South Texas Project Electric Generating Station P.O. Box 289 Wadsworth, Texas 77483

March 17, 2016
NOC-AE-16003347
10 CFR 50.90
File No. G25

South Texas Project
Units 1 and 2
Docket Nos. STN 50-498, STN 50-499
Request for Additional Information Regarding the License Amendment Request
For Extension of Containment Leakage Rate Testing Program
South Texas Project Units 1 and 2 TAC NOS MF6176 and MF6177

STPNOC Responses to the Request for Additional Information Regarding Units 1 and 2 License Amendment Request for Extending the 10 year ILRT to 15 years, Nuclear Safety Advisory Letters (NSALs)-06-6, -11-5, and -14-2, and InfoGram (IG)-14-1.

Figure 1
Containment Pressure (psia) with Uchida/Tagami Heat Transfer
Coefficient (HTC)

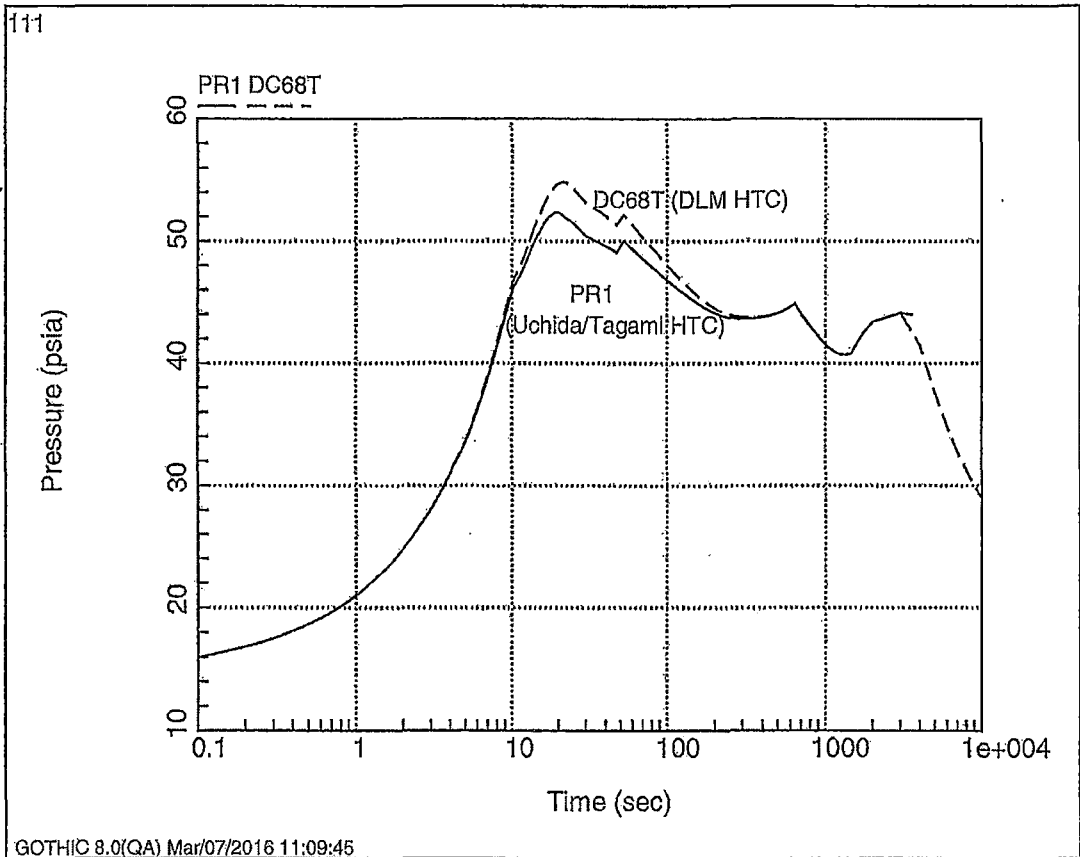
Two significant modeling changes were made when converting from the CONTEMPT to GOTHIC computer models. The first change replaced the Uchida/Tagami condensing heat transfer model with the Diffusion Layer Model (DLM) as discussed in Section 3.3.2 of Reference 1. A sensitivity study was performed using the limiting peak pressure case which is the Double-Ended Hot Leg (DEHL) break with minimum safety injection and minimum containment heat removal systems. Results of the study presented on Figure 1 below shows that the use of the GOTHIC DLM model resulted in a 2.7 psi increase in the peak pressure for the limiting case.

**Containment Pressure (psia) with No SPLIT or Liquid/Vapor Interface
heat transfer**

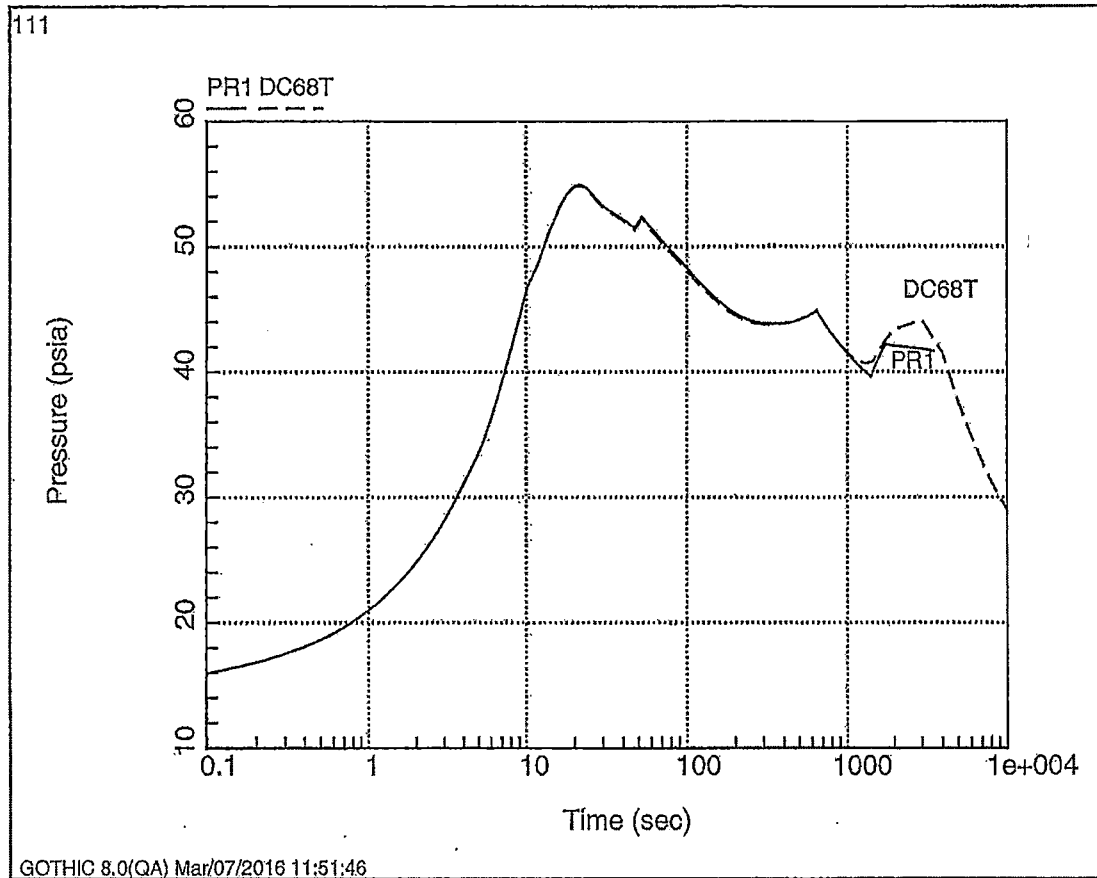
The second change added the liquid/vapor interface model between the atmosphere and the sump. The CONTEMPT model used a constant heat transfer coefficient of $0.4 \frac{\text{btu}}{\text{hr-ft}^2-\text{°F}}$ while the GOTHIC model used a split heat transfer option that switches the heat transfer from the vapor phase to the liquid phase as discussed in Updated Final Safety Analysis Report (UFSAR) Table 6.2.1.1-9. A separate sensitivity study was performed using the same limiting case discussed earlier. The results presented on Figure 2 below show that the change in the liquid/vapor model had a negligible change on the peak pressure.

Figure 3
Peak Pressure Composite for Equipment Qualification

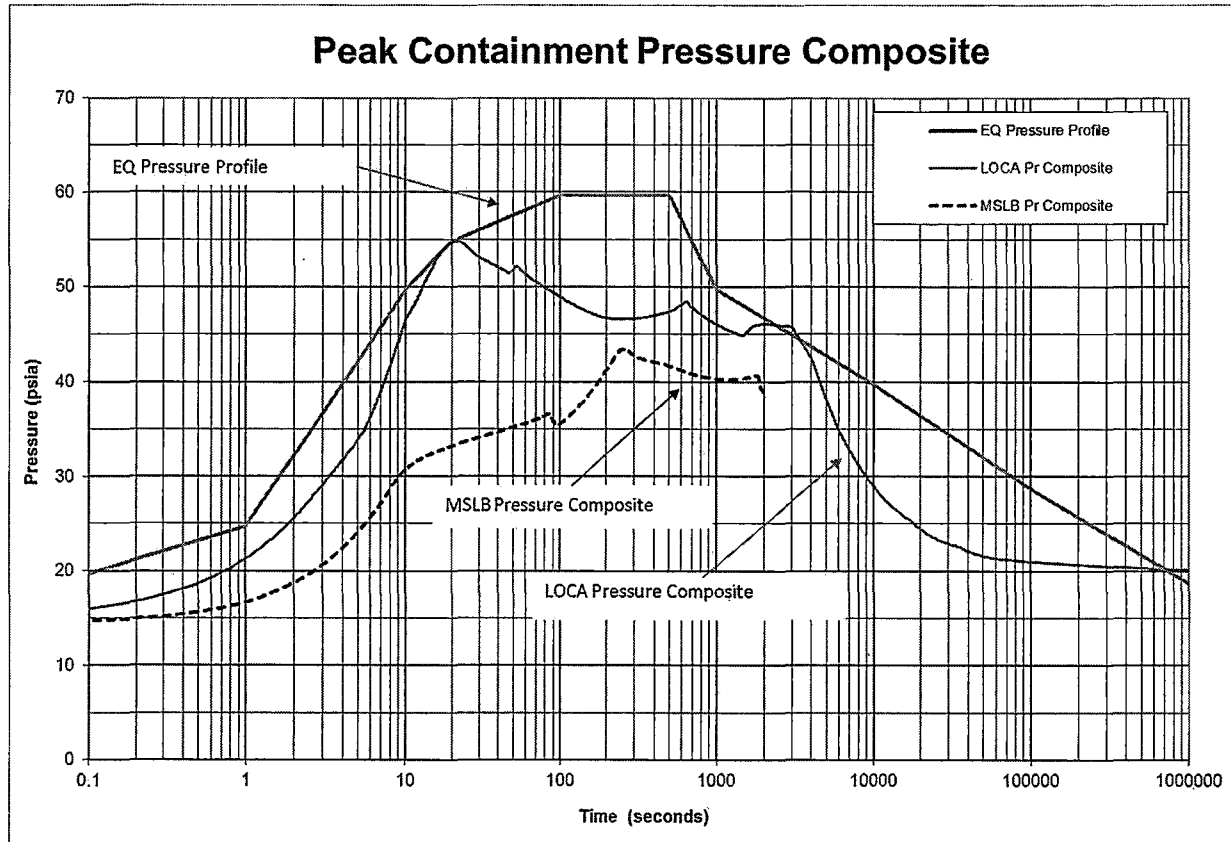
1.2 Please describe which UFSAR sections and figures contain the revised results of the LOCA mass and energy releases, containment pressure response, and Equipment Qualification pressure/temperature response analyses.

Figures 3 and 4 below present the equipment qualification pressure/temperature response. These figures are a composite of the peak pressures and temperatures from the LOCA and steam line break analyses.

Figure 5
Containment Pressure (psia) with Energy Multiplier of 1.02 (2%)

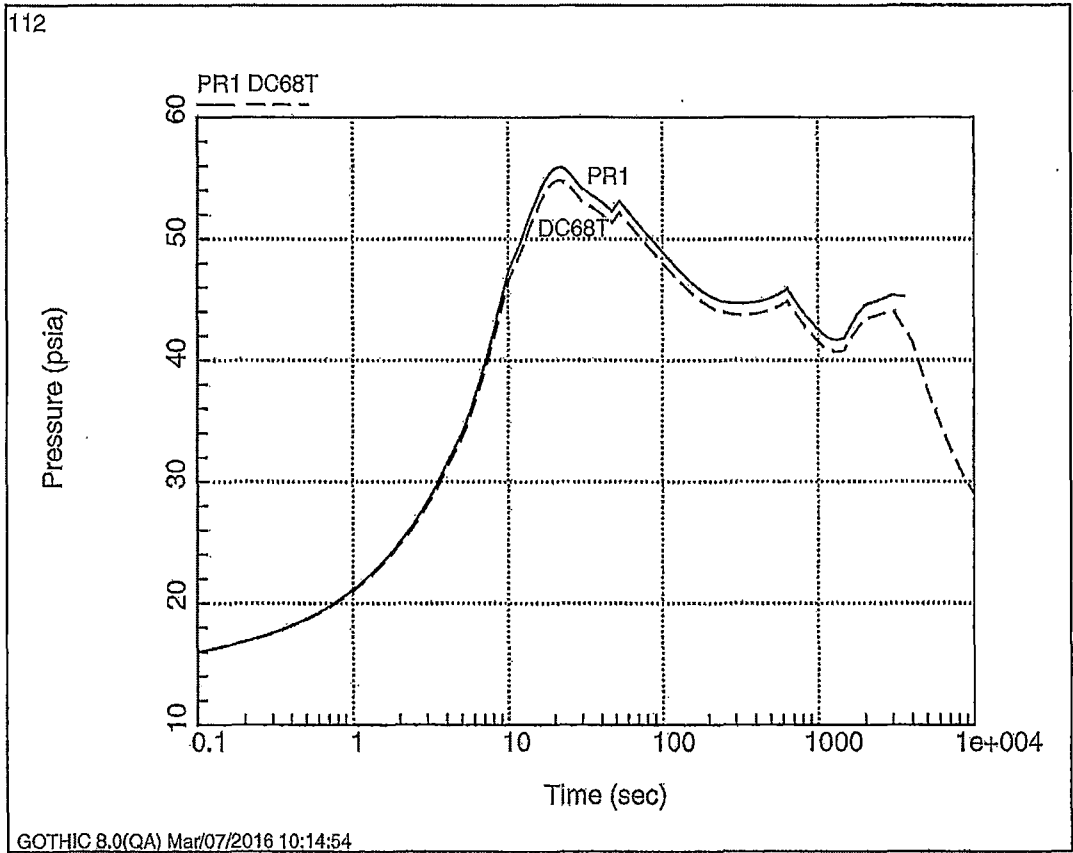
IG-14-1 identified that the stainless steel volumetric heat capacity value that is used in the Westinghouse LOCA M&E release analysis methodology was identified as being lower than the current ASME Boiler and Pressure Vessel Code data. IG-14-1 concluded that the current Westinghouse LOCA M&E release methodology provides a conservative calculation of the energy release rate for input to containment calculations, the methodology has been proven to be overall conservative for containment integrity and downstream analyses, including EQ, and no further action on the part of the utility is required. Additional discussions with Westinghouse identified that the stainless steel specific heat values used in the current analysis were approximately 20% lower than the current ASME Boiler and Pressure Vessel Code data.

The sensitivity study calculated the additional energy from the metal mass that would be required to increase the peak containment pressure from 40.1 psig to 41.2 psig (Pa). The premise of the sensitivity study is that an increase in the specific heat of the stainless steel would proportionately increase the energy release from the primary and secondary metal. Therefore, if the specific heat were to double, the energy release from the primary and secondary metal mass metal would also double. The LOCA containment pressure-temperature analysis uses the mass and energy releases for the first 3600 seconds, with the sensible energy from the RCS and steam generators being transferred to the sump; after 3600 seconds, energy addition is by decay heat only.

The GOTHIC model used for the design basis analysis was modified to add a multiplier to the energy release for the duration of the mass and energy releases to determine the energy required to increase the calculated peak pressure from 40.1 to 41.2 psig. The resulting pressure versus time is provided on Figure 5 which shows that the first peak is limiting. The results of the analysis show that a factor of 1.02 is required to raise the calculated peak pressure to 41.2 psig. UFSAR Table 6.2.1.3-18 shows that the total energy release to containment (Total Effluent) is 410.27 MBTU. So the additional energy added to containment during the blowdown phase is 8.2 MBTU (0.02×410.27 MBTU). The energy balance on UFSAR Table 6.2.1.3-18 shows that the energy contributed to the energy release by the primary metal (204.93 -192.02 MBTU) and secondary metal (161.72 – 156.81 MBTU) during the blowdown phase is 17.82 MBTU for the current analysis. The additional energy from the primary and secondary metal would have to increase by a factor 46% ($\frac{8.2 \text{ MBTU}}{17.82 \text{ MBTU}} \times 100$), which is greater than the additional 20% energy that could be provided by the differences in the specific heat values.
